Reinventing Borde Hill

Borde Hill Garden

Design Amendment Document

November 2025

Proposed site plan illustrating previously proposed (1) and currently proposed (2) play

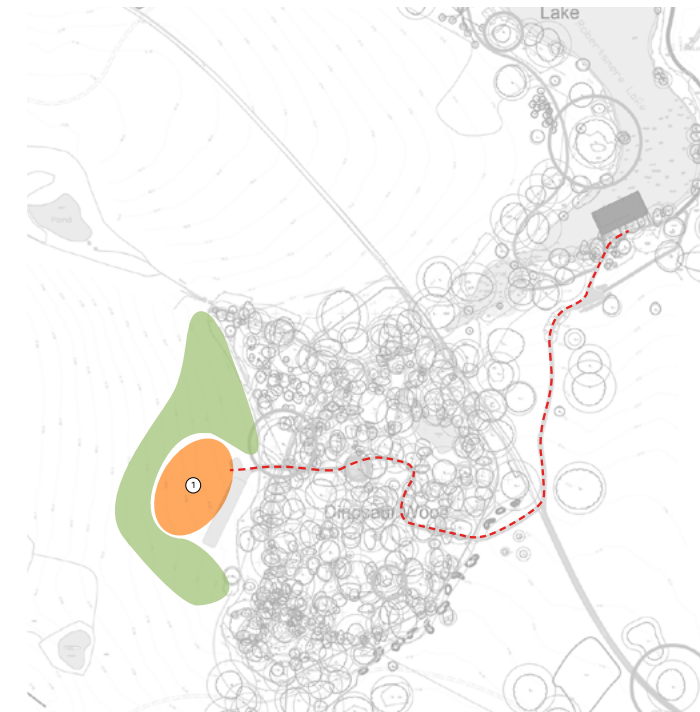
A key pillar of Reinventing Borde Hill is outdoor learning and play. Following feedback from the ecology officers, we have reviewed the proposed location of the play, to ensure there is no ecological impact to the site

- 1 Previous Location
- 2 Relocation of the play

The location of the play area has been altered due to the complexity of the mature trees and ecology in Dinosaur Wood.

Now situated outside of the ancient woodland and the 15m buffer, the new proposed location ensures no impact to the ecology of Dinosaur wood. The exercise also considered the existing topography and landscape features and their inherent play value.

Proposed site plan illustrating constraints of the site

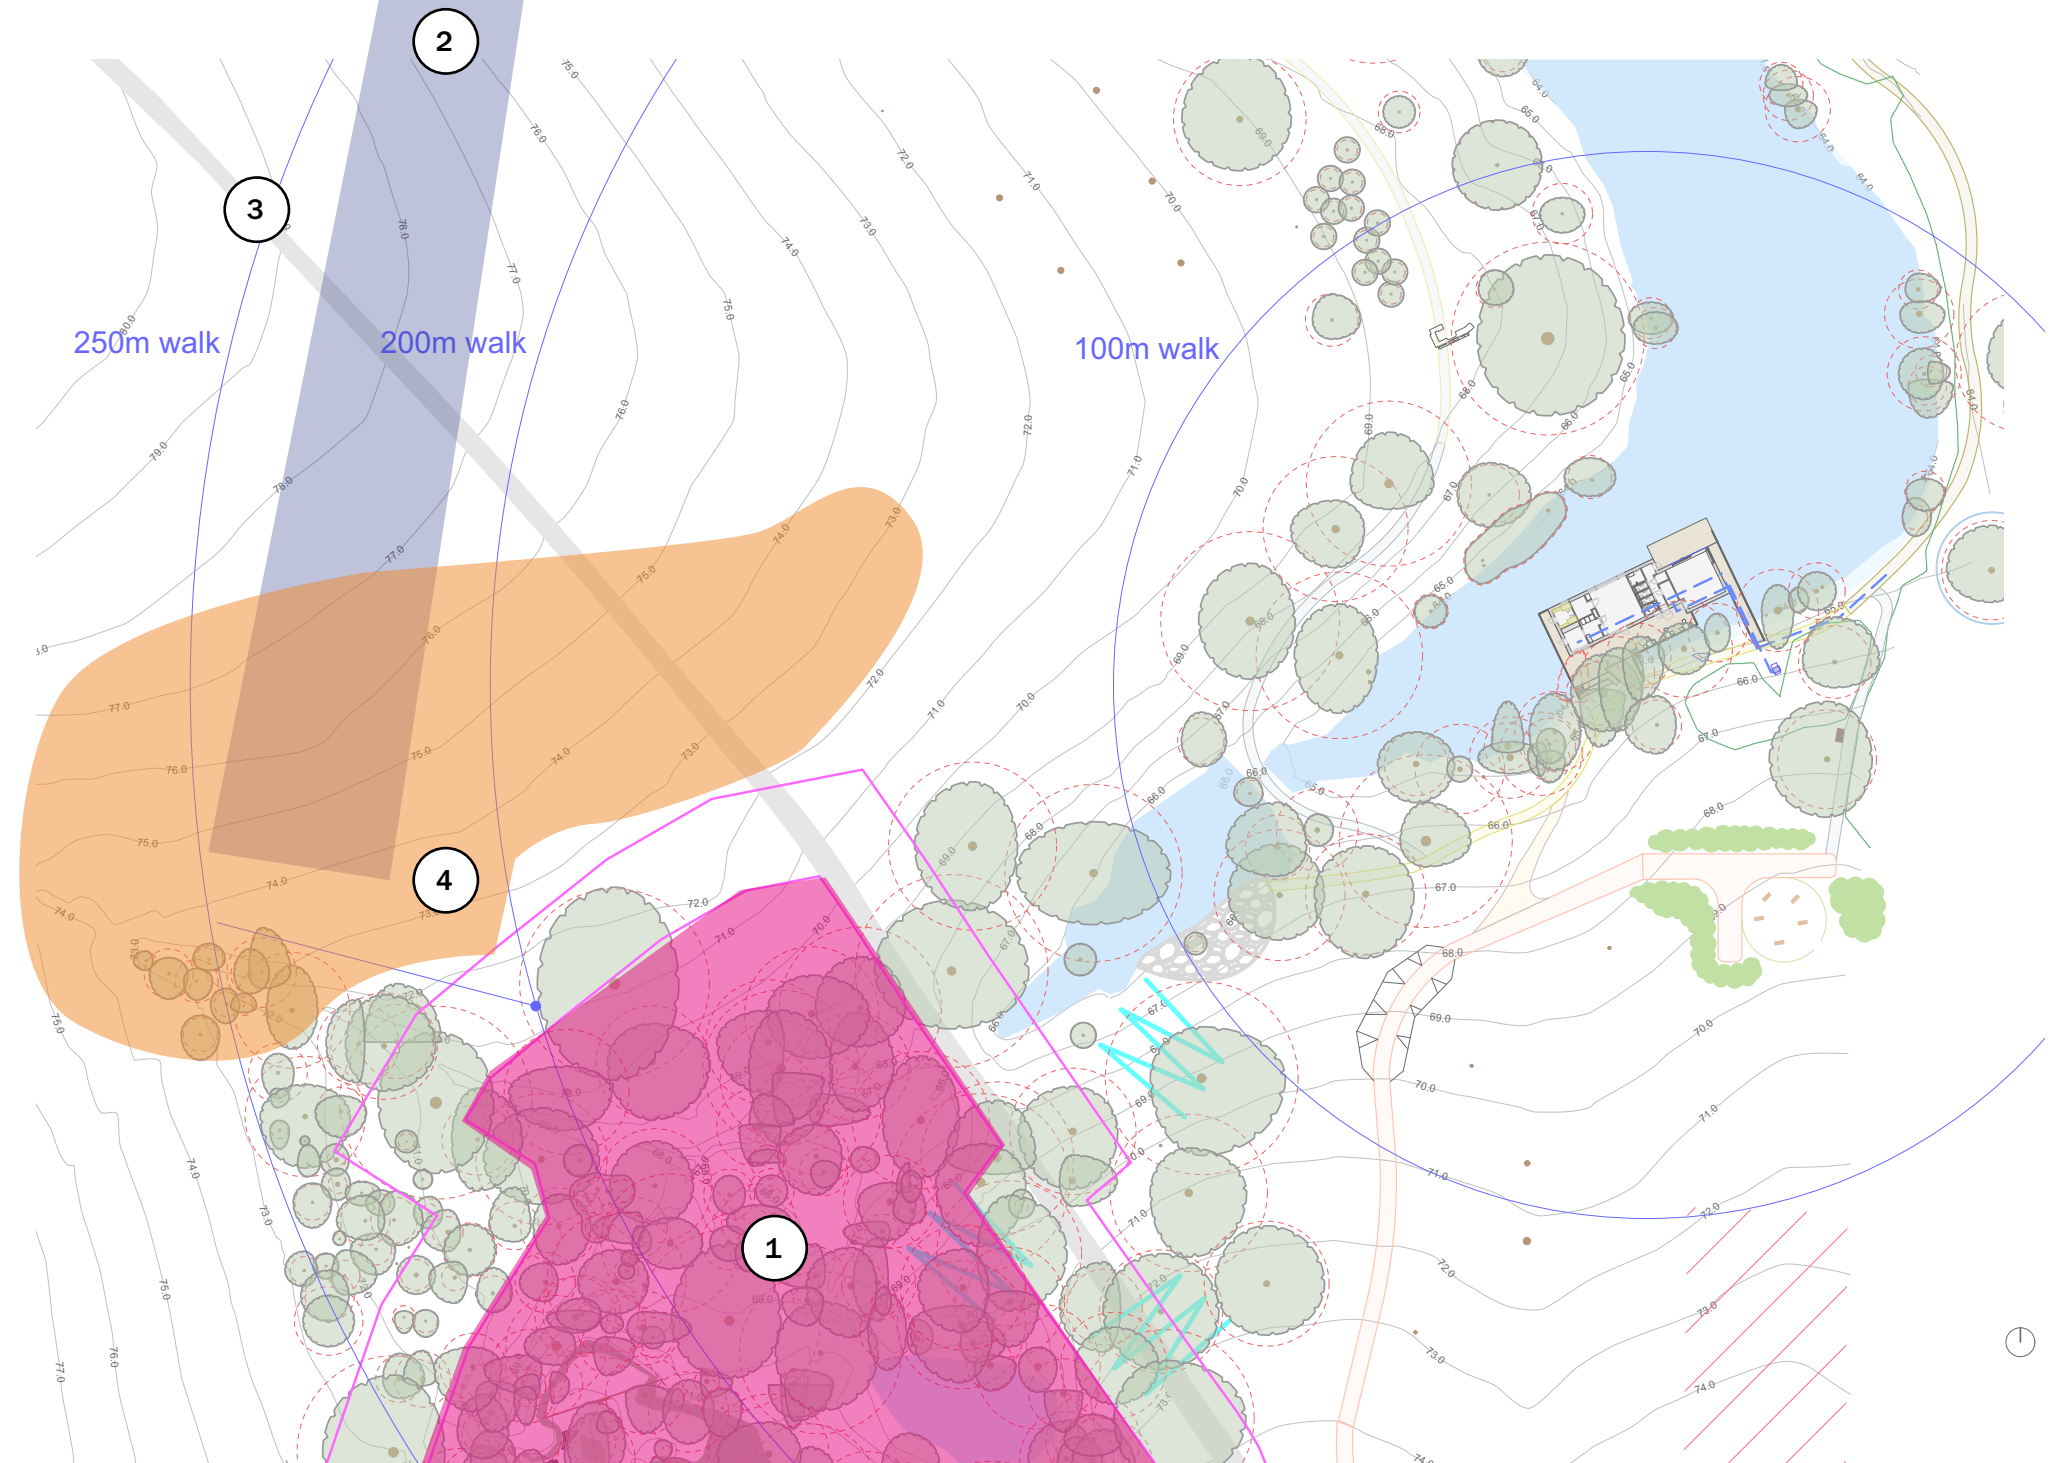
The chosen site has good proximity to the Eco Lodge whilst minimal impact to the heritage landscape. Situated now out of the ancient woodland and boundary and therefore its impact to the ecology of Dinowsaur wood is none.

- 1 Ancient Woodland Boundary + Ecology**
The chosen site is located outside of the ancient woodland boundary and at points within the buffer zone. It is noted that planting and access is permitted within this zone and the playground boundary treatment will be used to protect this boundary.

- 2 View of the play features from Borde Hill House**
The site is partially screened to Borde Hill House by the existing topography and headland trees. The play heights have been limited to a maximum of 6m to reduce any impact and views from the house. Planting to extend the woodland and wrap the play will act as a further screen

- 3 Walking distance from Eco Lodge and access to WC**
The chosen site is 200-250m away from the Eco Lodge, and therefore around a 5 minutes' adult walk.

- 4 Play Safety and landscape features**
The site features include a ghyll and scrub landscape as well as a small stream. ROSPA have been consulted initially on the safety principles of incorporating these features within the play offer.

Site plan illustrating viewing cone from Borde Hill House to the proposed play area

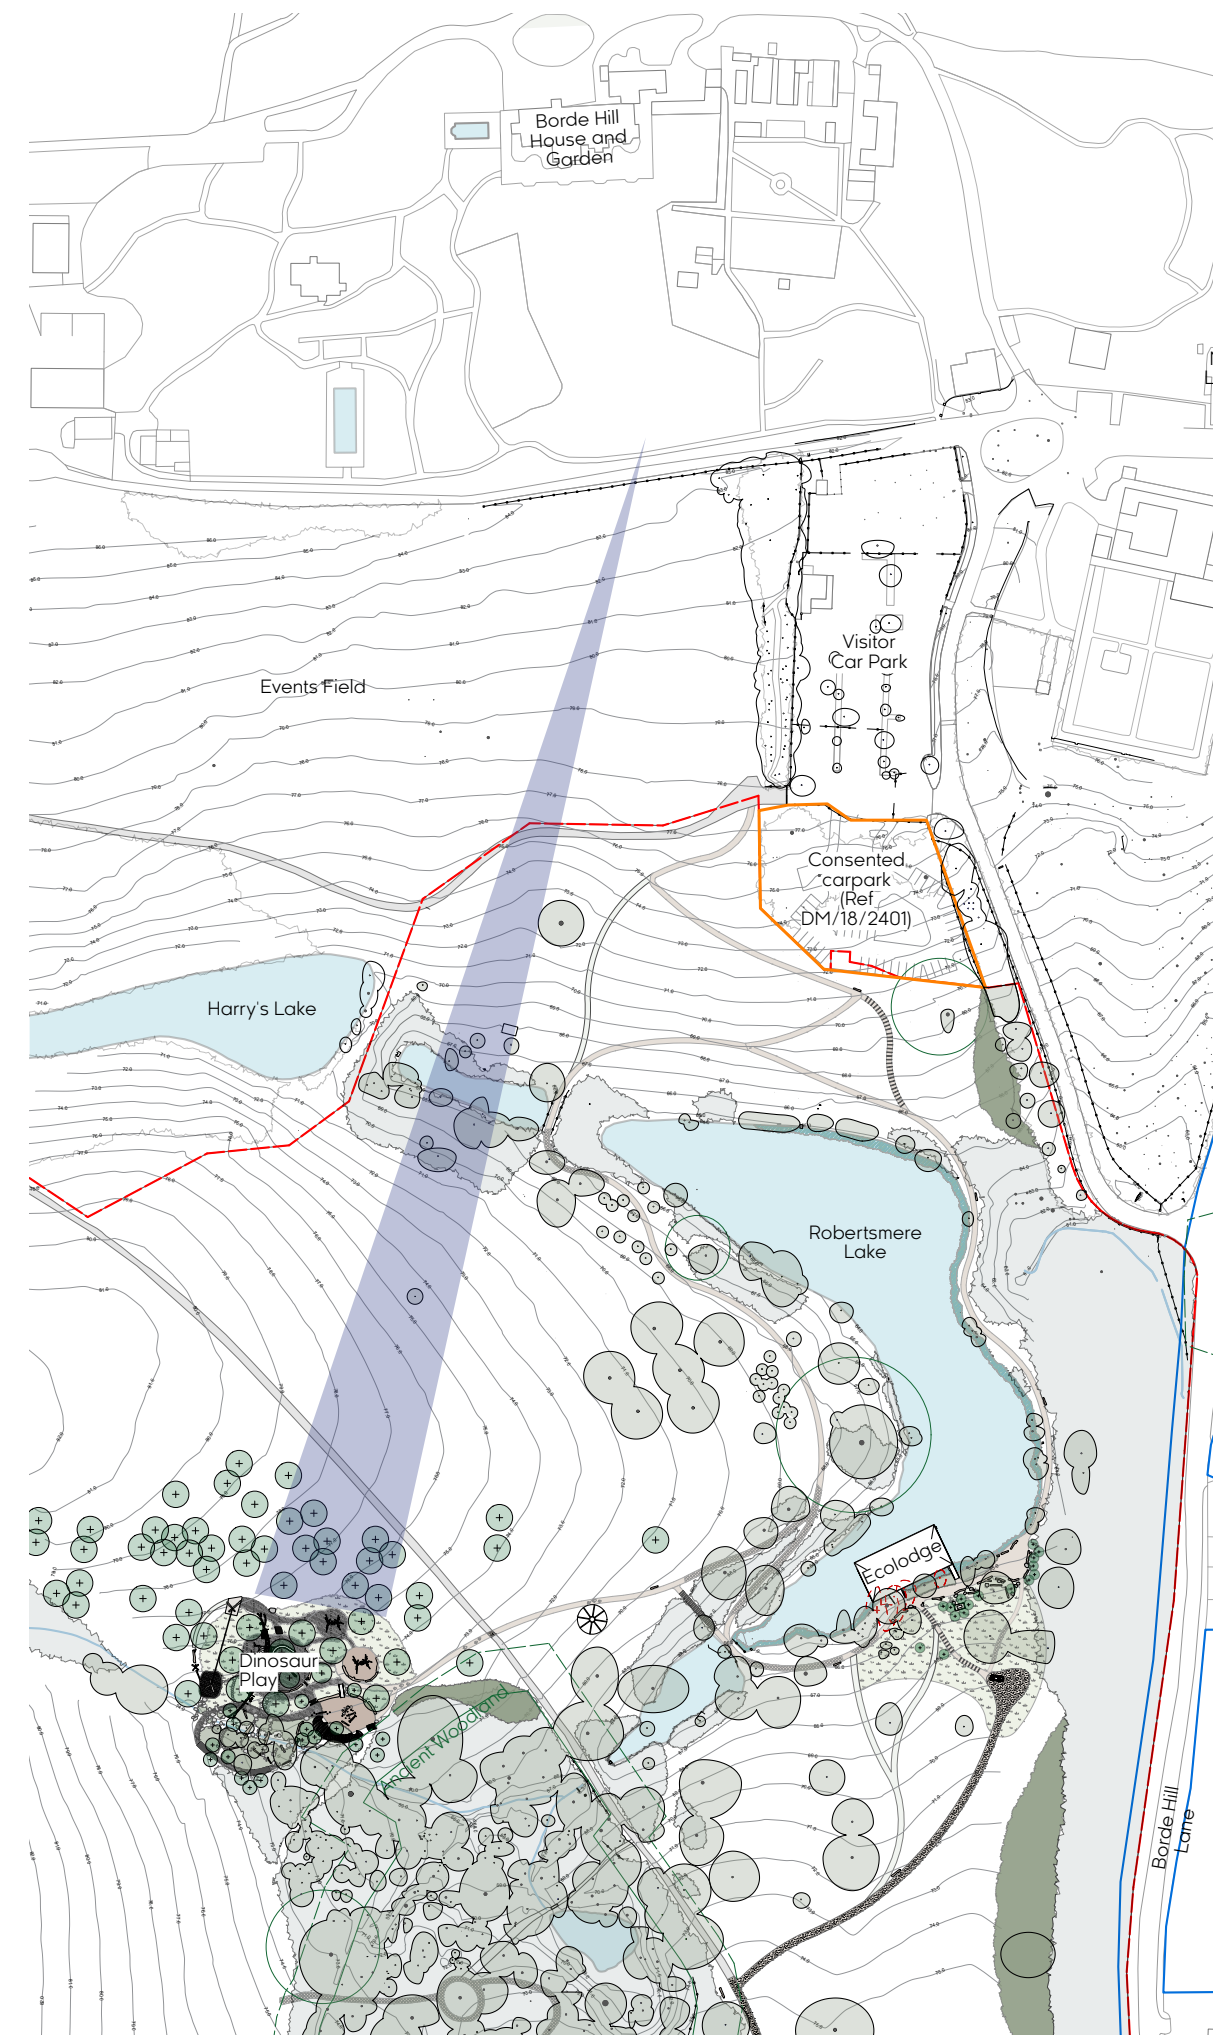
The new design for the natural play has considered the importance of the parkland trees and setting of the Borde Hill House and Garden which are to the north of the park. The following strategies have been considered in order to protect South Park:

- The siting of the play space is outside of the ancient woodlands and sits on the lee side of a rise in the open parkland topography.
- Significant views from the heritage assets are protected by the addition of new parkland tree groups and a linear parkland tree belt, which are characteristic of the South Park woodland pasture and the 18th century parkland style.
- The play structure's heights have been limited to a maximum of 6m to reduce impact.
- The play features are to be constructed from site won timber, which will be allowed to age naturally and sit well against the Parkland trees.
